MODIFICATION RECOMMENDED

N5224A-01

N O T E

N5224A PNA Series Microwave Network Analyzers

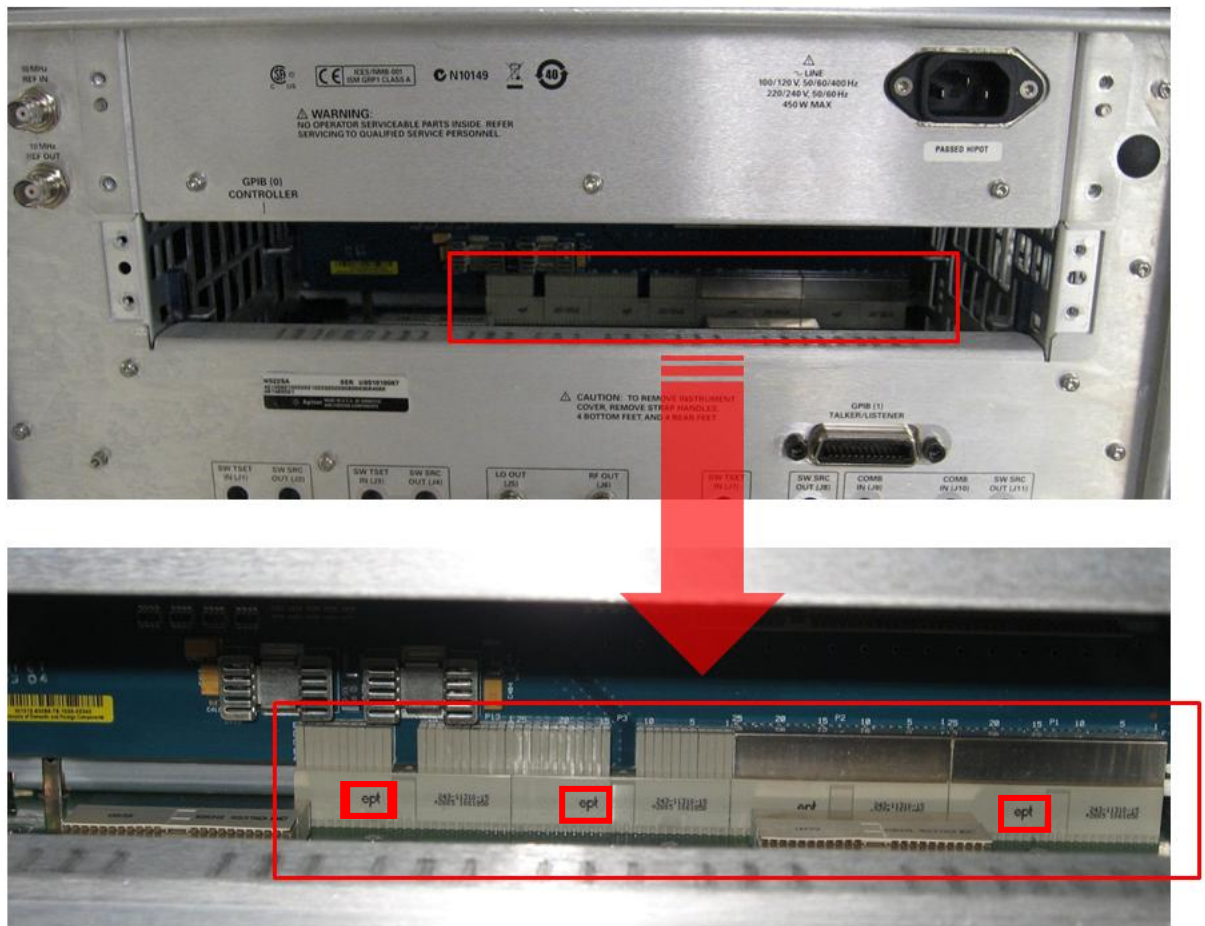
1. Remove the CPU assembly from the analyzer's rear panel. Refer to the PNA Service Guide chapter 7 section titled, "Removing and Replacing the CPU Board Assembly" for removal and reinstallation procedures. To view the online Service Guide, see the numbered list on the next page for instructions.
2. As per the photo below, inspect the system motherboard connector to see if it has one or more "ept" logos.

3. If the connector has one or more “ept” logos, return the analyzer to Agilent for replacement of the system motherboard. If the connector does not have one or more “ept” logos, email support_ctd-soco_support@agilent.com, providing the analyzer model and serial number and details of the malfunction symptoms.

4. *For Agilent Service Technicians only:* Only new boards without “ept” logos should be installed. Before installing the new board, look to see if it has one or more “ept” logos. If so, email support_ctd-soco_support@agilent.com, providing the analyzer model and serial number. Wait for further instructions in an email reply. New boards without “ept” logos can be installed.
For installation instructions, refer to the PNA Service Guide chapter 7 section titled, “Removing and Replacing the System Motherboard.” To view the online Service Guide, see the numbered list on the next page for instructions.
